Tauranga Control Zone (CTR) Review.

Airways New Zealand Final Petition
to
The Director of Civil Aviation
to
Amend the Tauranga CTR/D
and
Add a new Tauranga CTA/D 1500ft to 2500ft
and
Add a new Tauranga CTA/D 2000ft to 2500ft

20 March 2015

Airways submit a petition to amend controlled airspace around Tauranga as detailed and supported by this document.

Diagram 2 Runway 25, Turns at 700 (green), 1500 (yellow), 1700 (white), and 2000ft (magenta).

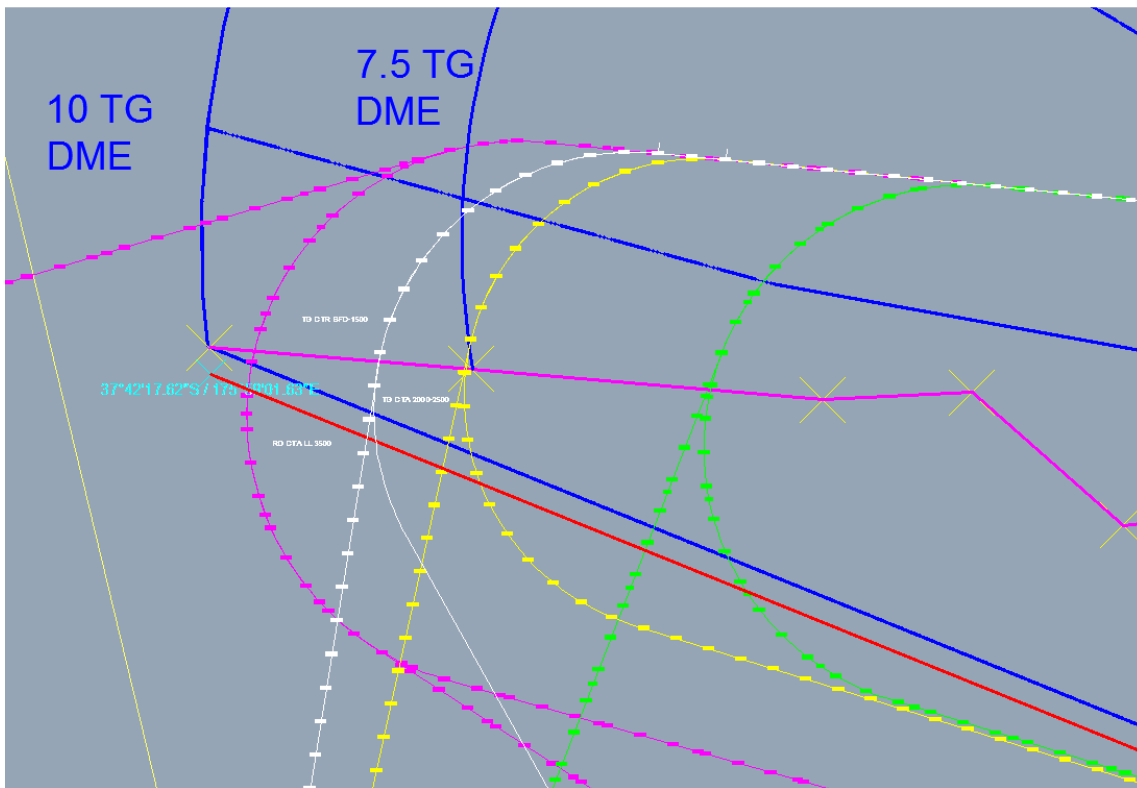
The attached diagram shows average departure paths off runway 25 based on this 5% gradient, and includes examples of turns at 700ft (existing), 1500ft, 1700ft, and the proposed 2000ft. As can be seen, none of these options are fully contained within the proposed and existing airspace. The boundary between the proposed Tauranga CTR and the southern proposed CTA is represented by the magenta line cutting horizontally across the second picture, and for containment aircraft would need to cross this line at 2500ft or above. Though the 1500, 1700 and 2000ft turn altitudes achieve this none reach the required 4000ft at the Rotorua CTA boundary. As noted in John’s initial report this is still better than the existing (lack of) containment, though consultation with CAA will be required to determine whether this is deemed acceptable.

Applying a 500ft tolerance at the airspace boundaries for containment requires an altitude of 2500ft crossing the magenta line from the TG CTR to the proposed CTA, then 4000ft crossing the red line into the Rotorua CTA.

Turn Alt	CTR Boundary (2500+)	CTA Boundary (4000+)	7.5 TG DME (2000+)	10 TG DME (3000+)
700	1800	2300	2300	3000
1500	2500	2800	2300	3000
1700	2800	3000	2200	3000
2000	3100	3200	2200	3000

Departing Runway 25 none of the proposed or sampled turn altitudes will keep aircraft continuously contained within the revised airspace structure based on a 5% climb gradient. Should CAA accept this a 1500ft turn altitude would provide better economy than the proposed 2000ft turn. Alternatively a 1700ft turn could give consistency if the same were kept off Runway 07.

Diagram 3 Runway 07, Turns at 1400ft (green), 1700, (existing, yellow) and 2000ft (cyan)

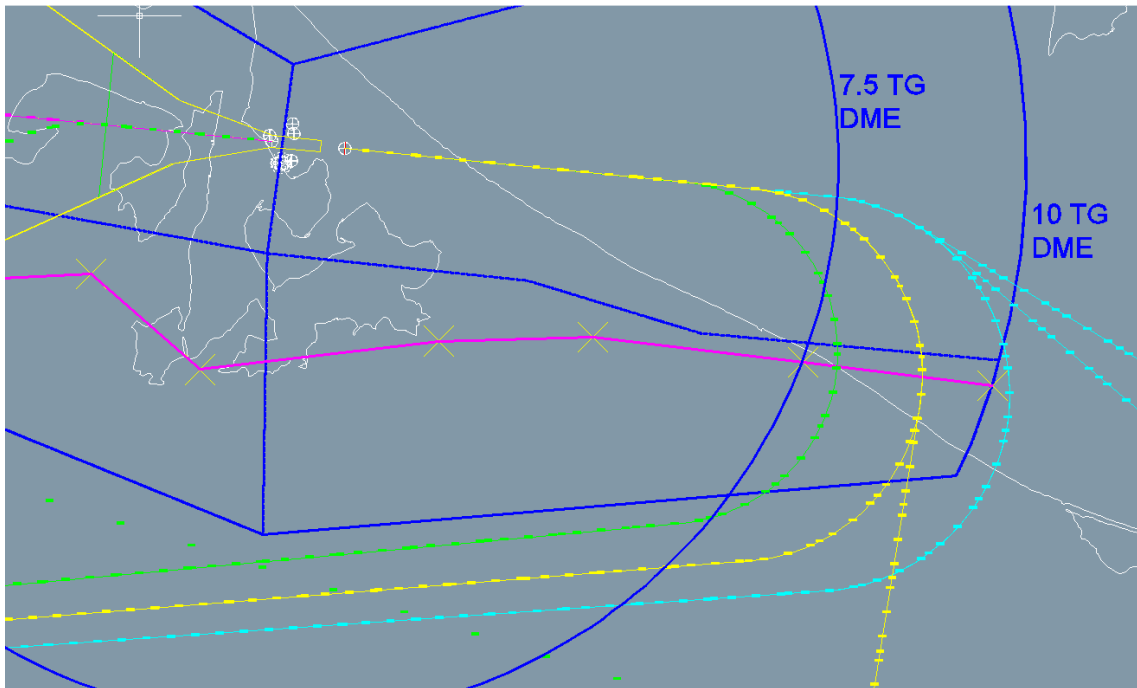
Because the runway is located to the east of the DME station the control zone is effectively shorter to the eastern boundary. The calculations below show that it takes just over 6.5nm for an aircraft departing Runway 07 to reach 2000ft. This distance from the threshold equates to approximately 7.3DME, already approaching the limit of the proposed CTR. This will mean that the turn radius for the average departure path with a 2000ft turn will take the aircraft outside of 10 TG DME.

I have included alternative turn altitudes of 1400 and 1700ft in the Diagram below.

Turn Alt	CTR Boundary (2500+)	CTA Boundary (3000+)	7.5 TG DME (2000+)	10 TG DME (3000+)
1400	2500	3100	2100	2900
1700	2800	3200	2000	2900
2000	Turn radius east of 10 DME ~3200ft	2900	2000	2900

There is no advantage to increasing the turn altitude off Runway 07 because departing aircraft are entering a lower sector of the RO CTA. This plus the shorter physical distance to the CTR boundary means that the 1700ft turn is more likely to remain contained within controlled airspace than the 2000ft turn due to the radius remaining inside 10 TG DME.
